SERVICE BULLETIN REVISION NOTICE

ENGINE INDICATING — EXHAUST GAS TEMPERATURE (EGT) WIRING HARNESS AND
JUNCTION BOX ASSEMBLY — REPLACE WITH THERMOCOUPLE WIRING HARNESS
ASSEMBLY

Turbojet Engine Service Bulletin No. V2500-ENG-77-0015 Revision No. 1 dated August 3, 2017.

ENGINE INDICATING — EXHAUST GAS TEMPERATURE (EGT) WIRING HARNESS
AND JUNCTION BOX ASSEMBLY — REPLACE WITH THERMOCOUPLE
WIRING HARNESS ASSEMBLY

REMOVAL OF WIRING HARNESS AND BRACKET ASSEMBLY
FIGURE 1, SHEET 1

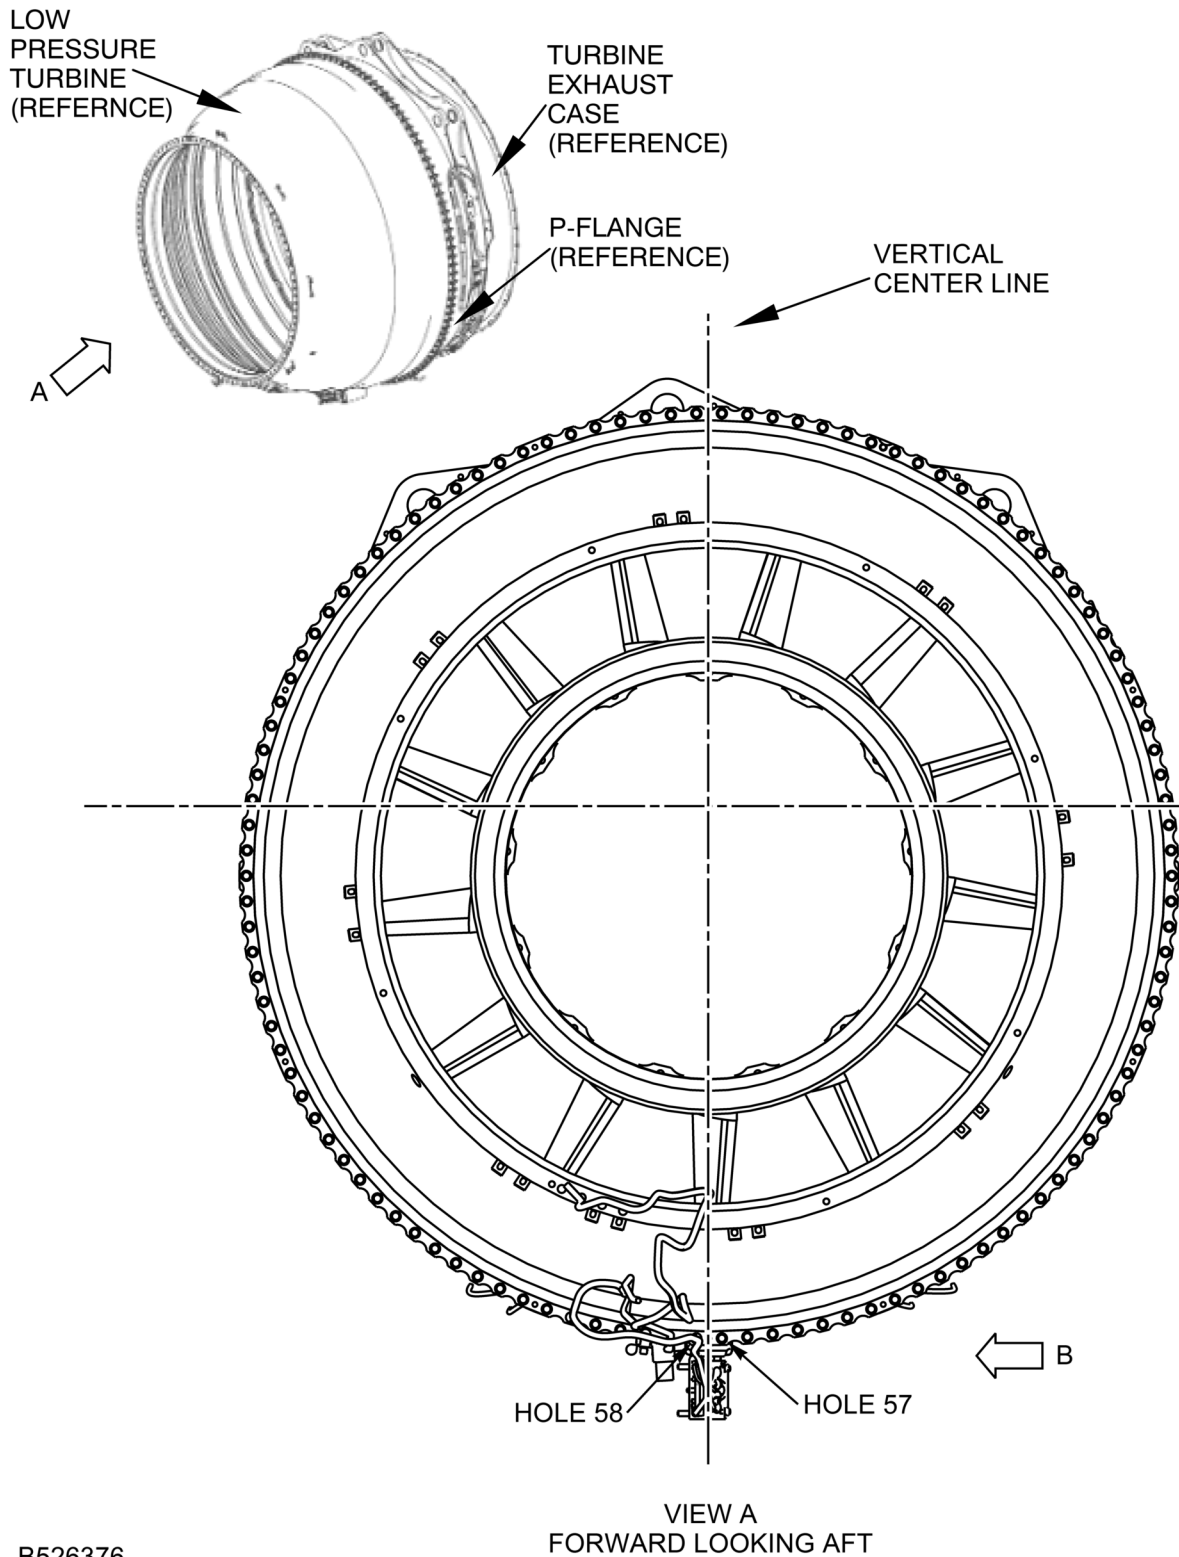
1. Remove the Cable TC Box, PN 2A4337 per Reference 5, Engine Manual, TASK 72-00-50-050-002-B00. See Figure 1, Sheet 1 and Sheet 2.

REMOVAL OF WIRING HARNESS AND BRACKET ASSEMBLY
FIGURE 1, SHEET 3

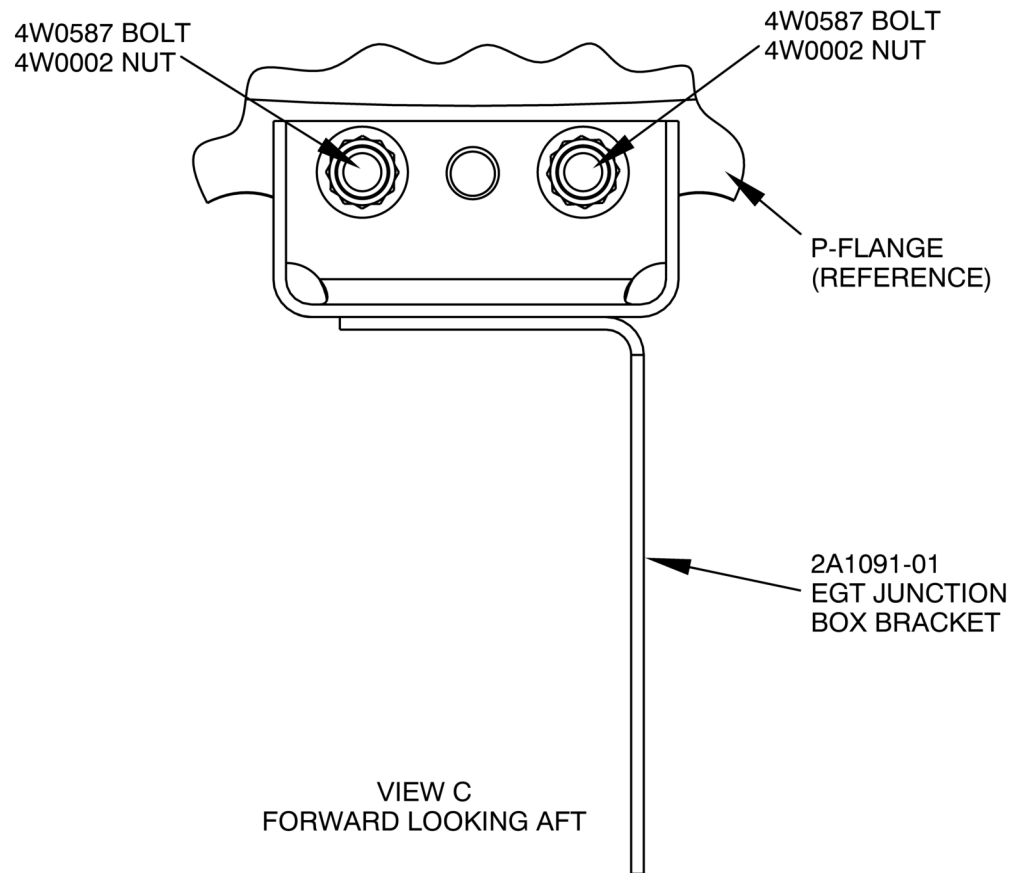
2. Remove the EGT Junction Box Bracket, PN 2A1091-01 from the engine.
 - A. Remove and retain the two Bolts, PN 4W0587 and two Nuts, PN 4W0002 that attach the bracket to the engine at the P-flange holes 57 and 58. See Figure 1, Sheet 3.
 - B. Discard this bracket and make it unserviceable in an acceptable manner which is described in Reference 11, FAA - Order: 8120.11 "Disposition of scrap or salvageable aircraft parts and materials", dated 2/12/96.

ACC PERISEAL CONNECTOR LOCATION
FIGURE 2

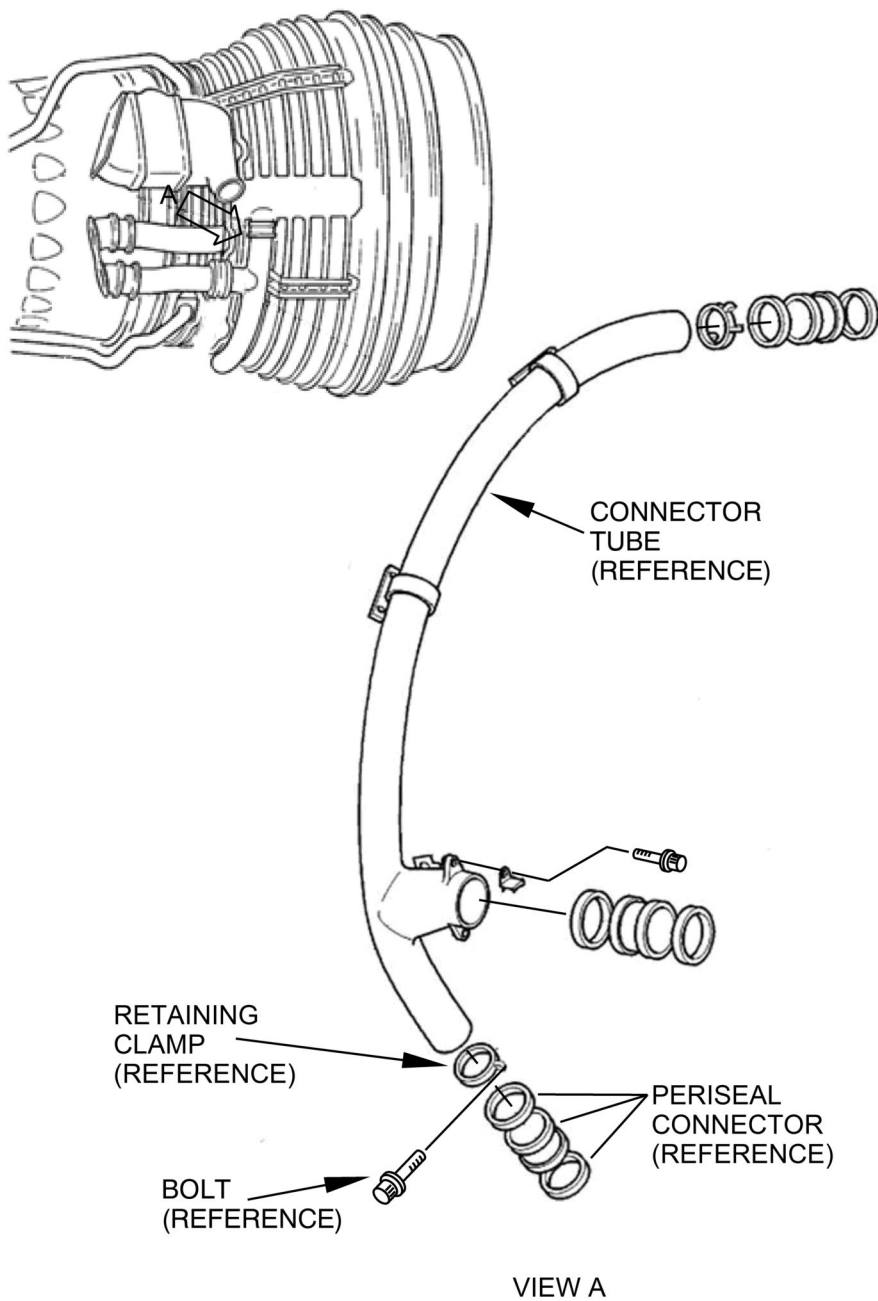
5. Move the Active Clearance Control (ACC) periseal housing. See Figure 2.
 - A. Loosen bolt on retaining clamp to allow clamp to move along tube.
 - B. Slide periseal connector along ACC tube until sufficient gap is present to route new EGT harness.

- C. Lower Harness Core Assembly, PN 6A5878, through gap created and remove from engine.
6. Assemble the ACC periseal housing. See Figure 2.
 - A. Feed Wiring Harness Thermocouple Assy, PN 2A4524 at harness marked location through periseal gap.

- B. Move periseal connector on lower ACC tube to the original position to cover the opening.
 - C. Ensure that the pin of the retaining clamp engages in the location hole in the ACC tube.

- D. Ensure that the two periseals are correctly seated in the U-slots of the periseal connector.
 - E. Torque the bolt on the retaining clamp to the periseal connector to between 36 – 45 lbf-in (4.1 – 5.1 Nm). Reference 3, Standard Practices and Processes, TASK 70-41-02-410-501.

INSTALLATION OF WIRING HARNESS BRACKET ASSEMBLY
FIGURE 3, SHEET 1

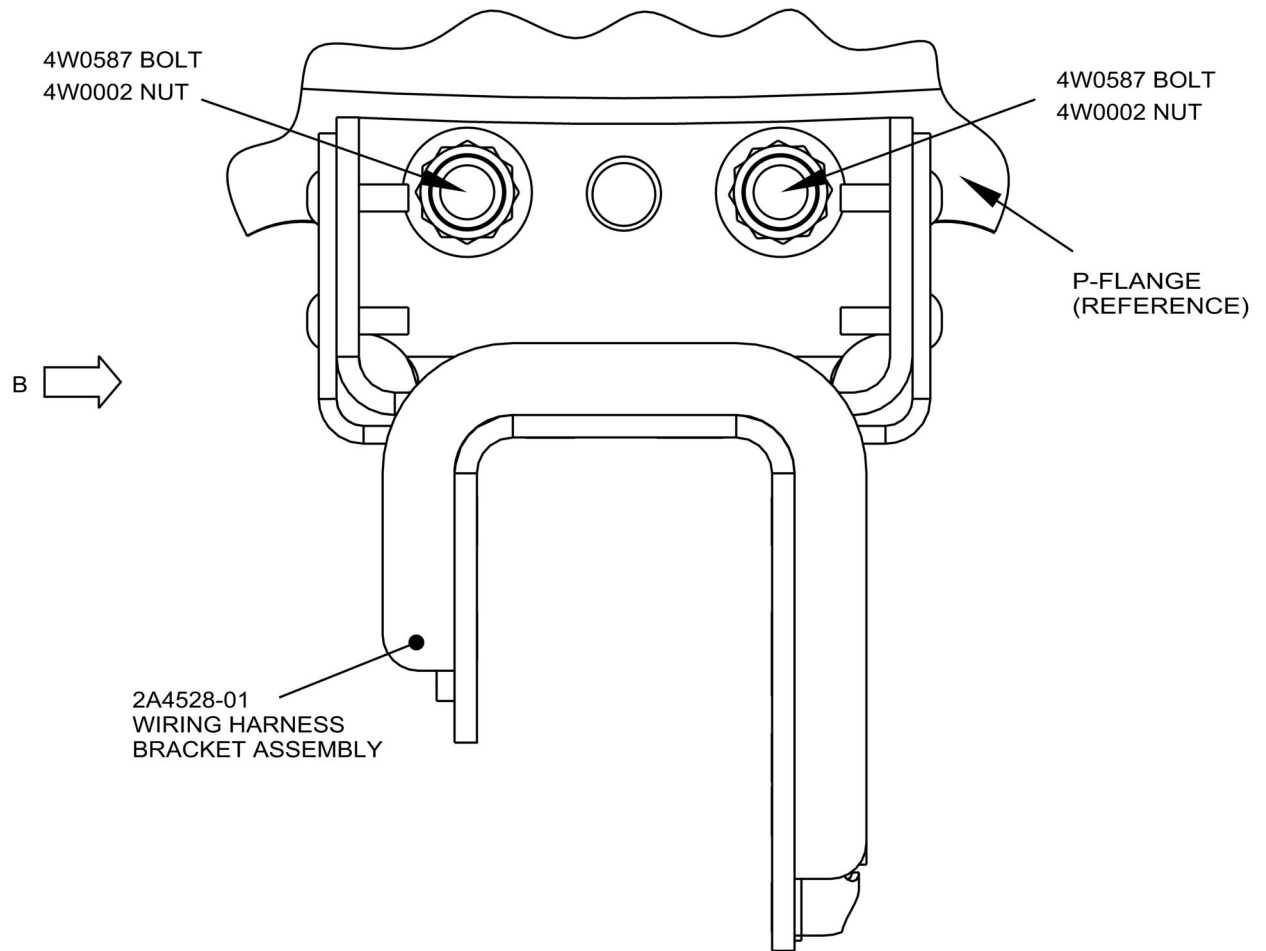
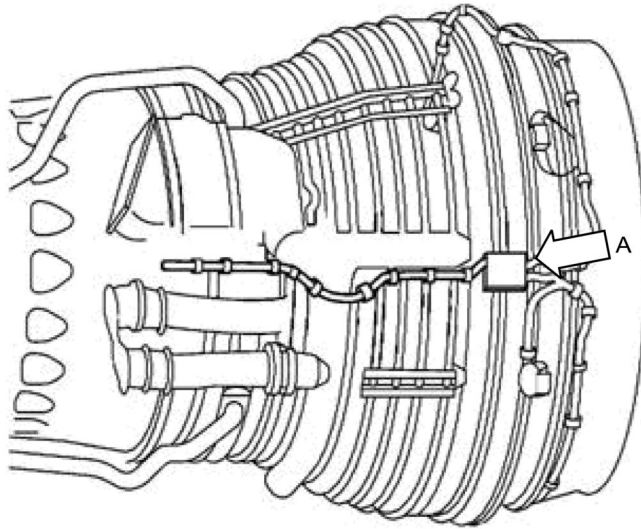
7. Install the Wiring Harness Bracket Assembly, PN 2A4528-01 as follows;
- A. Install the Wiring Harness Bracket Assembly, PN 2A4528-01 on the AFT side of the P-Flange at holes 57 and 58 using two Bolts, PN 4W0587 and two Nuts, PN 4W0002. See Figure 3, Sheet 1.

- B. Torque the bolts to between 85 – 105 lbf-in (9.60 – 11.86 Nm). Reference 3, Standard Practices and Processes, TASK 70-41-02-410-501.
8. Install the new EGT harness to the wiring harness bracket assembly at the P-flange.

INSTALLATION OF WIRING HARNESS BRACKET ASSEMBLY
FIGURE 3, SHEET 2

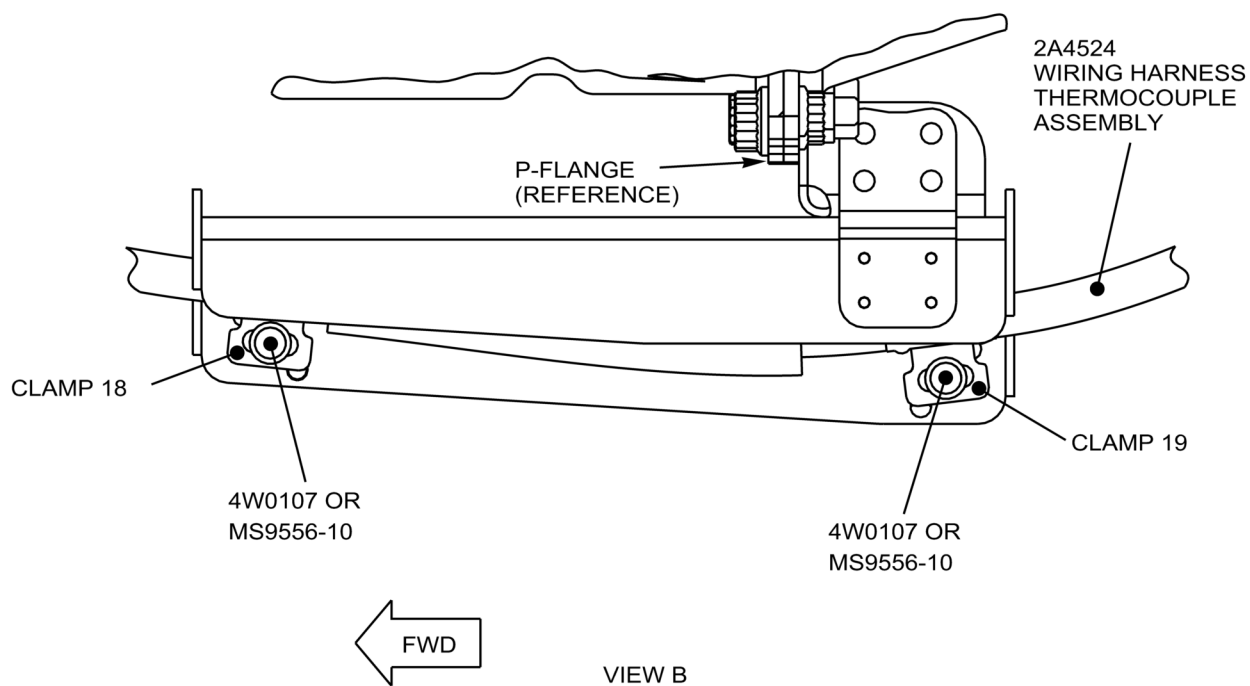
- A. Install the Wiring Harness Thermocouple Assy, PN 2A4524 integral clamps 18 and 19 to the Wiring Harness Bracket Assembly, PN 2A4528-01 on the P-flange using two Bolts, PN 4W0107 or PN MS9556-10. See Figure 3, Sheet 2.

- B. Torque the bolts to between 36 – 45 lbf-in (4.1 – 5.1 Nm). Reference 3, Standard Practices and Processes, TASK 70-41-02-410-501.
9. Install the Wiring Harness Thermocouple Assy, PN 2A4524 to the flange brackets AFT of the wiring harness bracket assembly. Reference 5, Engine Manual, TASK 72-00-50-450-002-B00.

AFT WIRING HARNESS CLIP LOCATIONS
FIGURE 4, SHEET 1

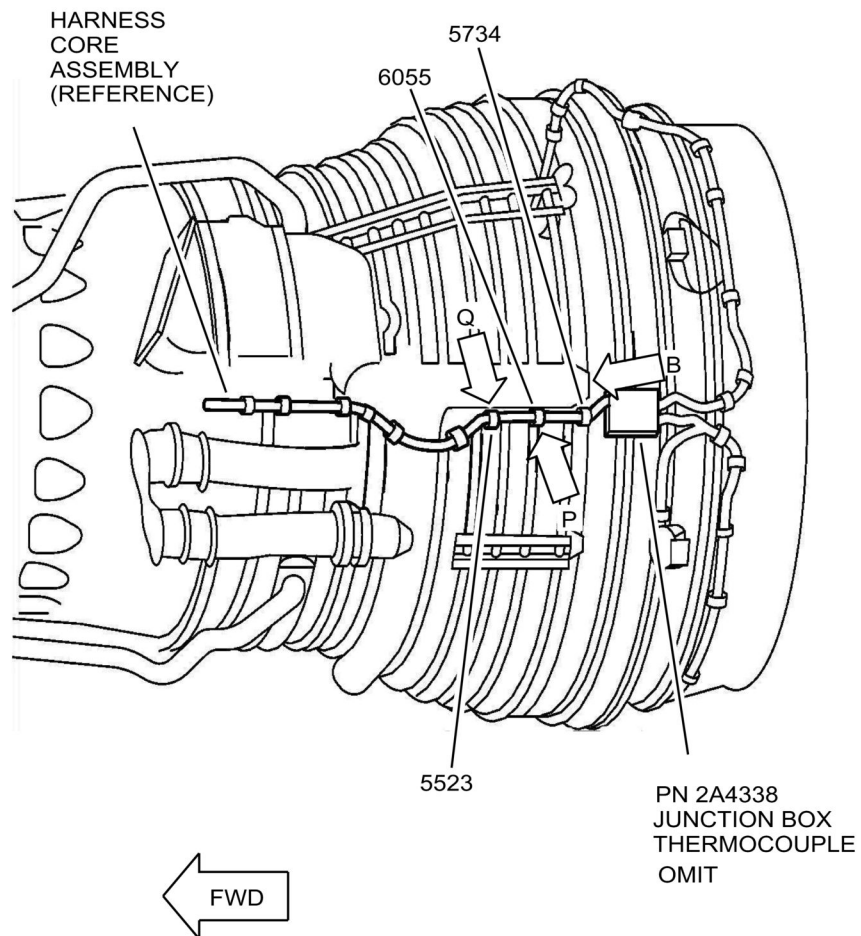
10. Install the new Wiring Harness Thermocouple Assy, PN 2A4524 forward of the supporting bracket replace Clamp, PN TA025022-05 with Clamp, PN TA025022-06 with the exception of the following steps. Reference 5, Engine Manual, TASK 72-00-40-420-007-B00.

- A. Install the harness at Position 5734 except omit the Clamp, PN TA025022-05. See Figure 4, Sheet 1 and Sheet 2.
 - B. Install the harness at Position 6055 except omit the Clamp, PN TA025022-05. See Figure 4, Sheet 1 and Sheet 2.

- C. Install the harness at Position 5523 except omit the Clamp, PN TA025022-05. See Figure 4, Sheet 1 and Sheet 2.
 - D. Install the harness at Position 5552 except omit the Clamp, PN TA025022-05. See Figure 5, Sheet 1 and Sheet 2.

FORWARD WIRING HARNESS CLIP LOCATIONS
FIGURE 5, SHEET 1

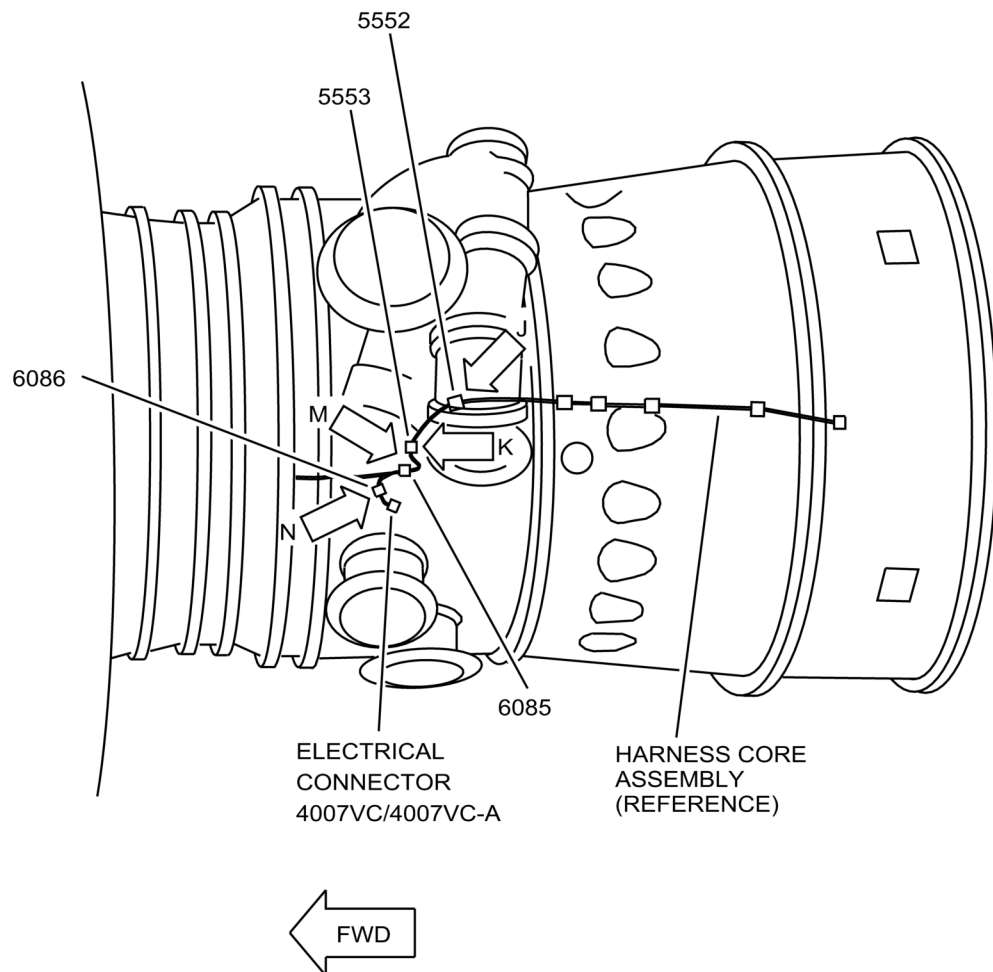
4. Inspect EEC Core Harness electrical connector 4007VC-A (which mates with EGT harness 4007VC). Examine the sockets (female contacts). See Figure 5, Sheet 1.
 - A. Examine sockets (contacts) for alignment and damage.
 - B. Examine to confirm no contacts are pushed rearward into the connector face.
 - C. Examine connector sockets for corrosion, deformation, distortion or discoloration by inserting a harness connector pin into each socket. Friction must be felt while inserting and removing the harness connector pin.
 - D. Replace contacts as necessary per Reference 3, Standard Practices and Processes, TASK 70-35-25-300-001 (VRS7002, Repair 001).

- E. Install the harness at Position 5553 except omit the Clamp, PN TA025022-05. See Figure 5, Sheet 1 and Sheet 2.
 - F. Install the harness at Position 6085 except omit the Clamp, PN TA025022-05. See Figure 5, Sheet 1 and Sheet 2.

- G. Install the harness at Position 6086 except omit the Clamp, PN TA025022-05. See Figure 5, Sheet 1 and Sheet 2.

REMOVAL OF WIRING HARNESS AND BRACKET ASSEMBLY
FIGURE 6, SHEET 1

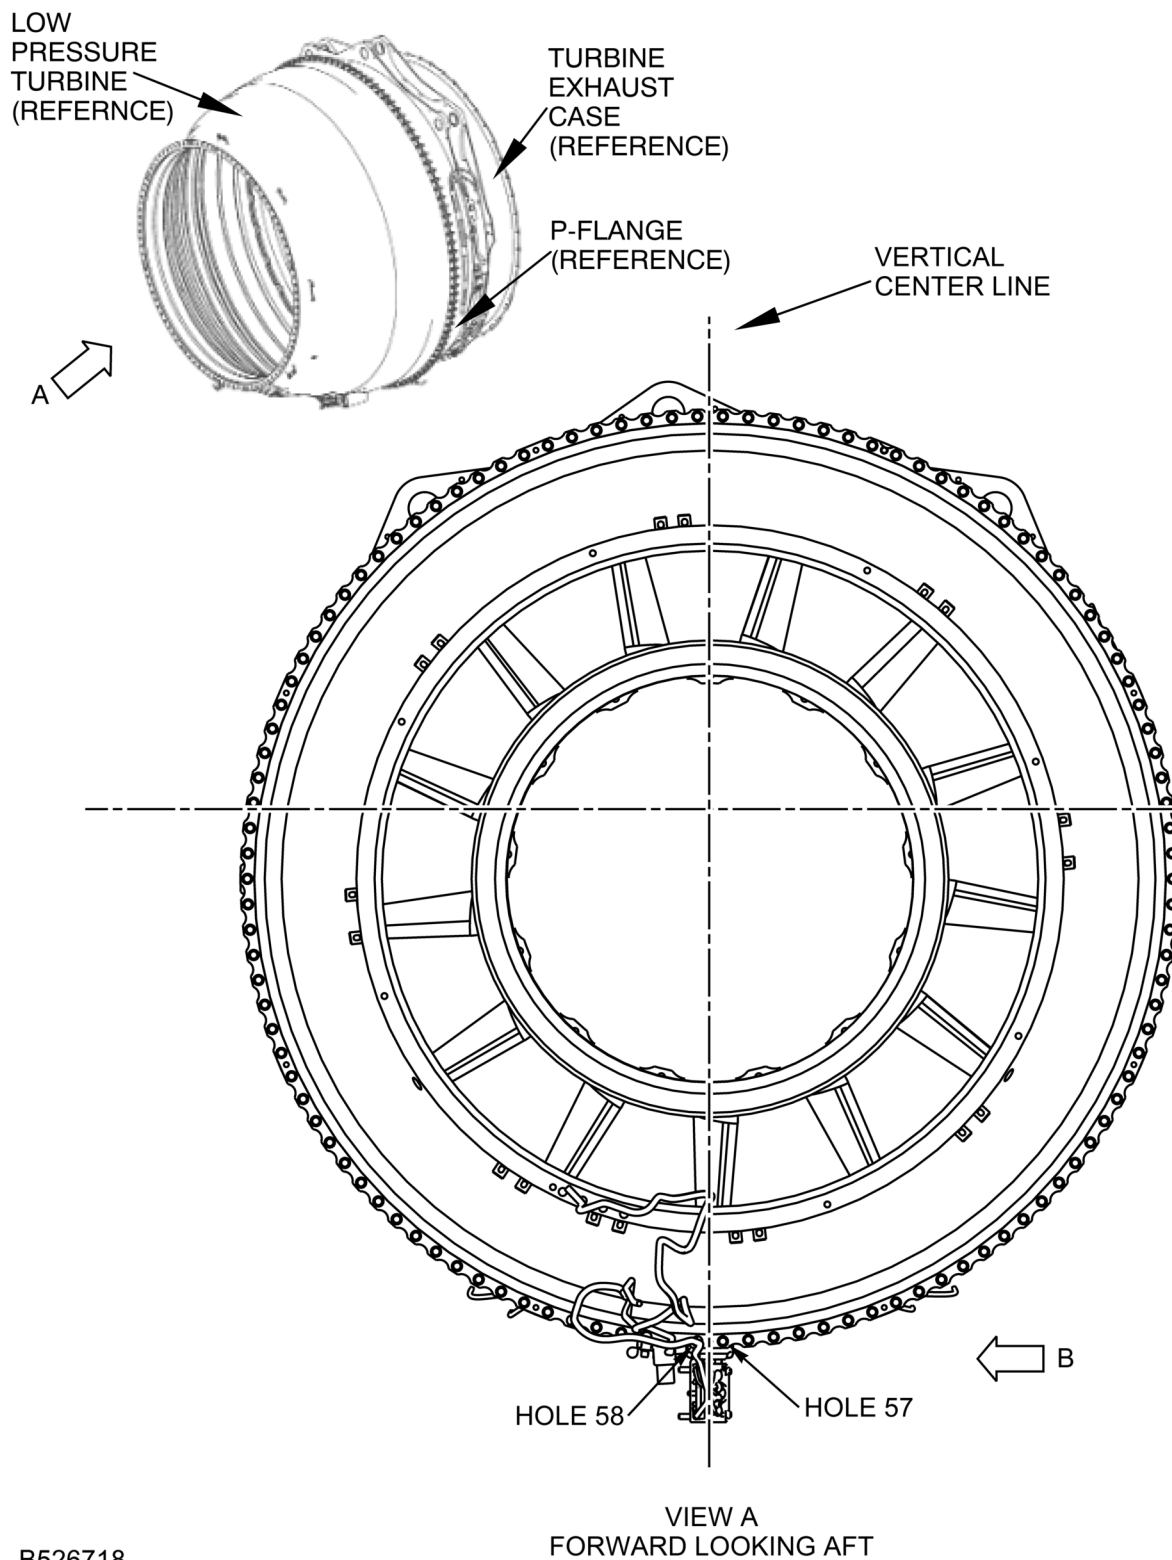
1. Remove the Cable TC Box, PN 2A4337 per Reference 6, Aircraft Maintenance Manual TASK 77-21-43-000-010-B. See Figure 6, Sheet 1 and Sheet 2.
